Issue Date	Rev	Description	Drawn	Checked
15/09/2016	A	ISSUED FOR DEVELOPMENT APPLICATION	DVI	LT
07/02/2017	B	DEFERRED COMMENCEMENT - DA AMENDMENTS	DVI	LT
13/03/2017	C	SECTION 96 - LIGHTWELL	DVI	LT
24/05/2019	D	SECTION 96	DVI	LT
APRIL 2020	F	REVISED SECTION 96	DVI	LT

PROJECT	
GARLING HOUSE PROPOSED NEW RESIDENCE 24 LANCASTER CRESCENT, COLLAROY NSW LOT 3 DP.11899	
FOR MR & MRS GARLING

DRAWING TITLE	
PLANS SITE PLAN	
SCALE 1:200, 1:100 @ A2	DRAWN BY LT/DVI
PROJECT NO. 1612	PLOT DATE 9/04/2020
	REVISION
	DA-01 F

PROJECT	DRAWING TITLE	SCALE	DRAWN BY	PLOT DATE
GARLING HOUSE PROPOSED NEW RESIDENCE 24 LANCASTER CRESCENT, COLLAROY NSW LOT 3 DP.11899	ELEVATIONS NORTH + EAST	1:100 @ A2	LT/DVI	9/04/2020
FOR MR & MRS GARLING	1612	DA-09	REVISION	F

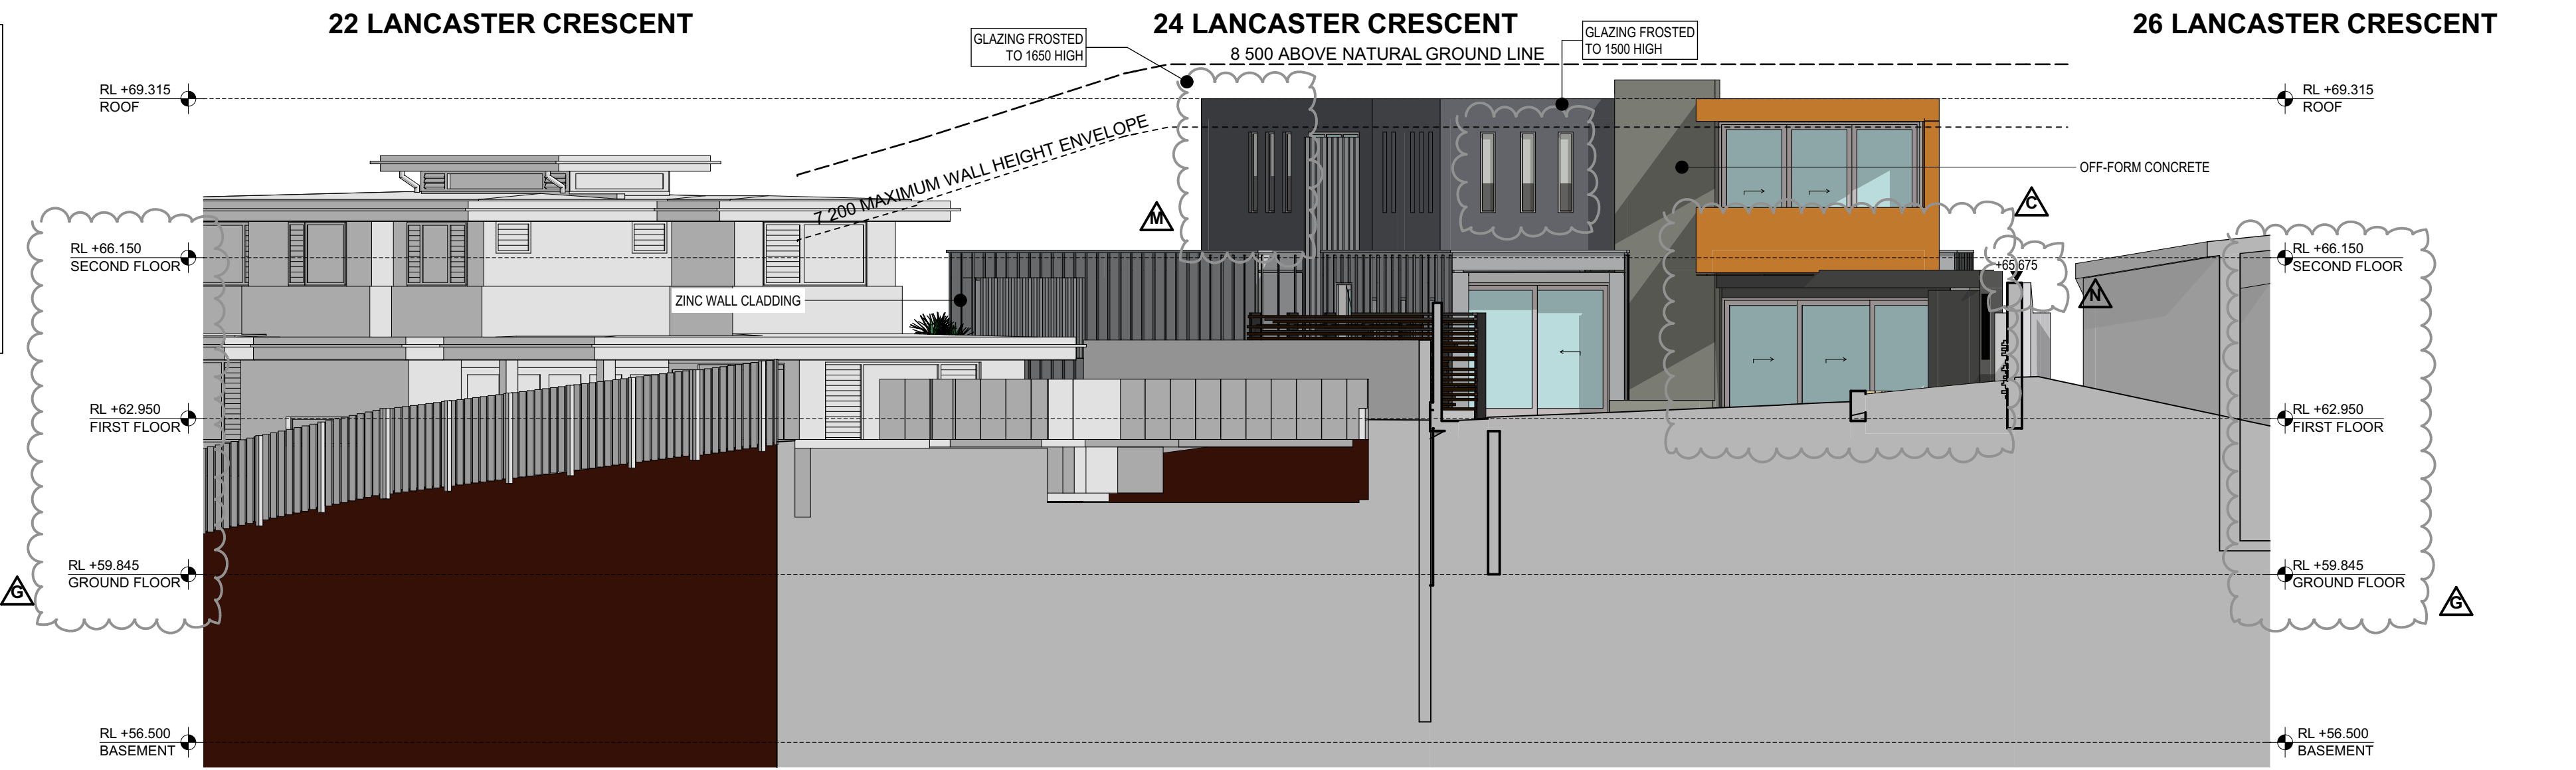
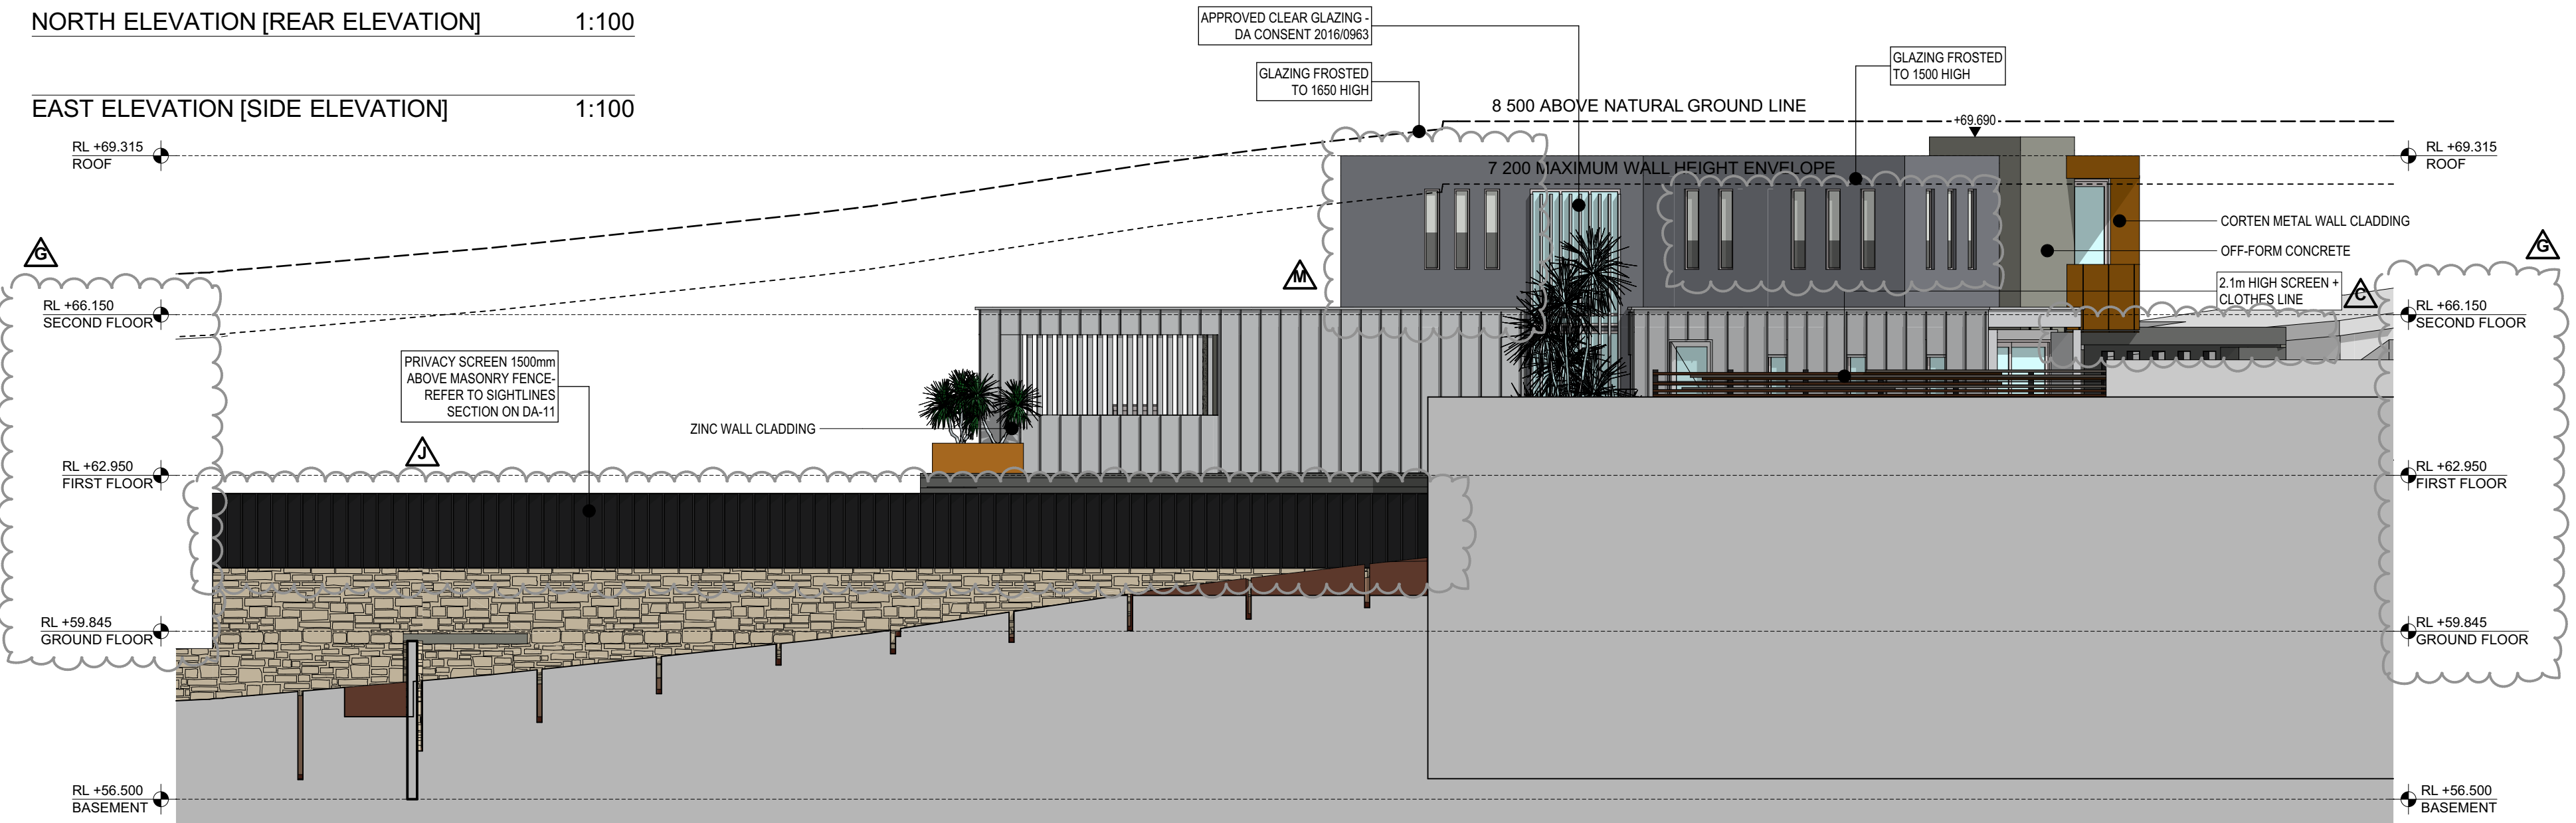
- SCHEDULE OF S96 AMENDMENTS**
NORTH + EAST ELEVATIONS
- REAR FIRST FLOOR DECK PEGOLA REVOMED AND NEW ROOF OVER DECK
 - FLOOR LEVELS AMENDED
NOTE NO IMPACT ON HEIGHT
ROOF LEVEL NOT CHANGED
 - BOUNDARY POOL PRIVACY SCREEN ADDED TO TOP OF WALL - 1500 HIGH REFER SECTION ON DA-11
 - MASTER BEDROOM DAY BED - OBSCURE GLASS TO 1650 HIGH WINDOW SLOTS ADDED EAST ELEVATION
 - BOUNDARY FENCE LEVELS ADDED
